277-281 Ingles Street, Port Melbourne

Application for Planning Scheme Amendment C181port

Appendix 2: Internal referral responses

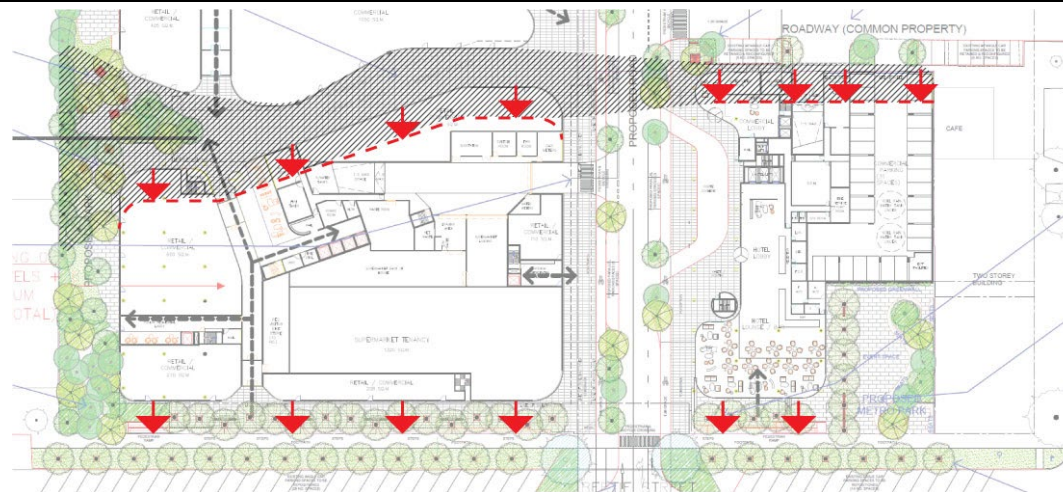
The current proposal aligns two proposed crossovers on the eastern title boundary of the Stage 1 development that should be avoided as a high priority. As the proposal is for a hotel, the valet function of the entrance should be seamless in its configuration and avoid unnecessary vehicle movements travelling around the block and diminishing pedestrian safety. It is recommended the crossover conflicts be removed from the future laneway interface and that the hotel podium parking be made accessible via the portes-cochère off the newly created local road. This will limit pedestrian / vehicle conflict, integrate land use and public transport and future-proof the 6m laneway as a potential pedestrian link connecting all future proposals north of the development to the Fishermans Bend Framework's future public transport interchange hub and Melbourne CBD.

It is also recommended that the portes-cochère be shifted west from the proposed location away from the pedestrian links and intersection.

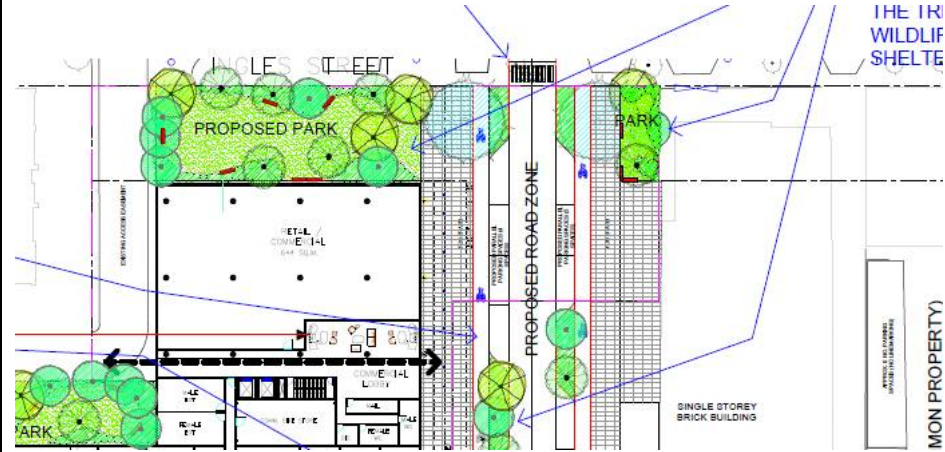
The intersection of Ingles St and Proposed Road Zone also have a linear park on either side. CoPP should consider the width of the linear park be extended across the carriageway to increase the functionality between these spaces. Potentially with a raised surface. Proposed park should provide more of an active function than urban forest.

Query if the proposed park to be delivered by the applicant? If so than should require that the space function in an active way and is connected to the other linear parks adjacent.

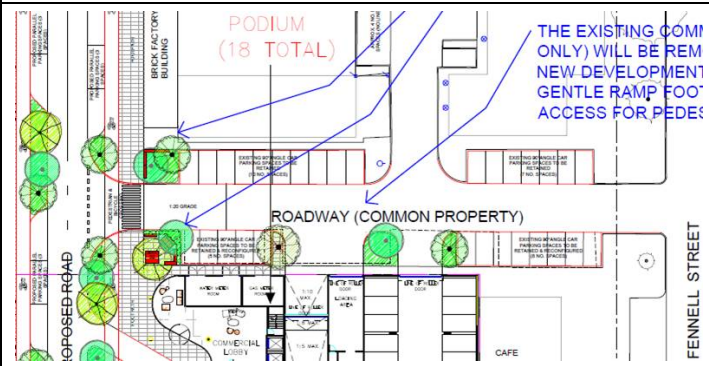
Intersection of Bertie St of Proposed Road Zone could have a wider pedestrian crossing that integrates the desire lines between buildings. The pedestrian crossing being so far from that desire line will mean that people will not cross legally. Suggest creating a raised table across the entire pedestrian/bicycle desire line.

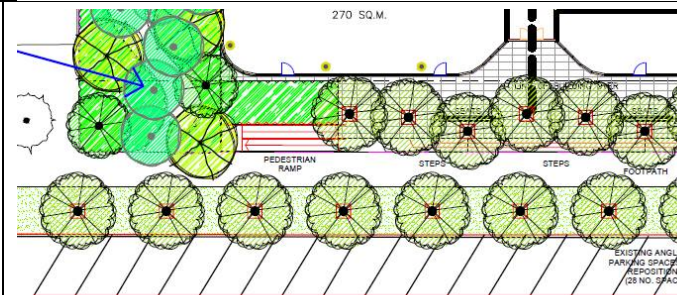
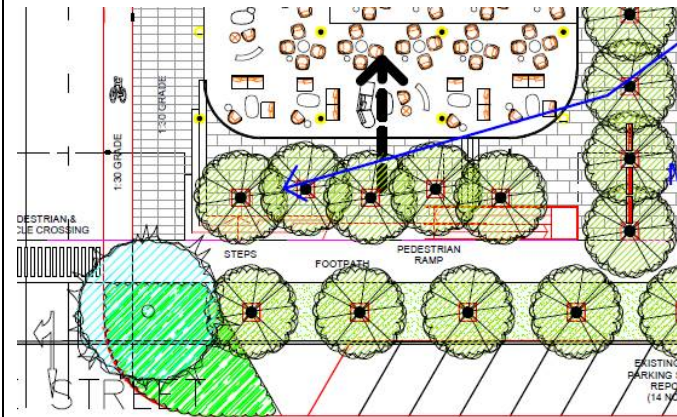
Suggest removal of car parking in the laneway (common property) and the reimagining of these spaces to more pedestrians uses. In the DDO32 the common roadway

Roadway (common property) should be redesigned to create an active frontage with 60% permeability.

should be a secondary type I (60% permeability) active frontage.

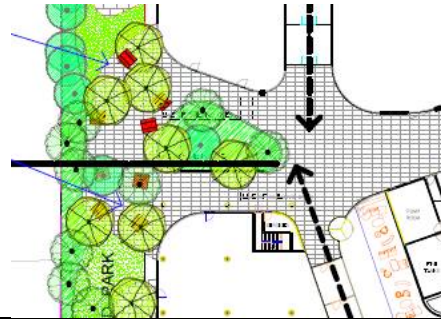
The public realm should be inclusive to all and not just accessible. Case-in-point, ramps should be integrated with the public realm rather than placed to the fringes. From McKenzie group: “The Building Code of Australia has adopted key accessibility and DDA legislation into the 2011 and subsequent BCA. In particular adherence to the Access to Premises Standard (2010) (APS); AS1428.1 2009; AS1428.4.1 2009 and AS2890.6 2009 has become mandatory. This means that compliance with the relevant

The applicant should ensure that the public realm provides equality, dignity and functionality for all people regardless of ability.

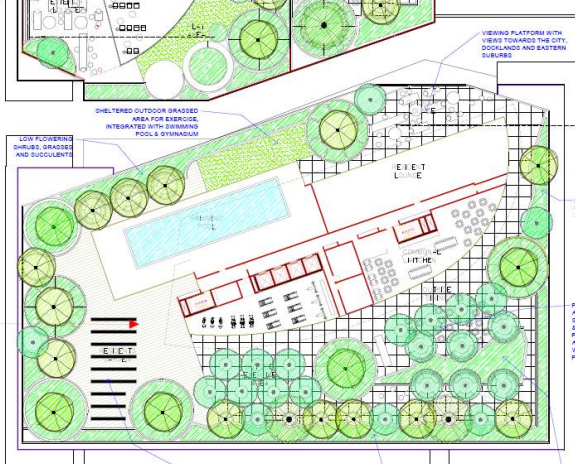
Similar comment to below.

Create an urban plaza from the linear park into buildings 3 and 4 from the proposed road
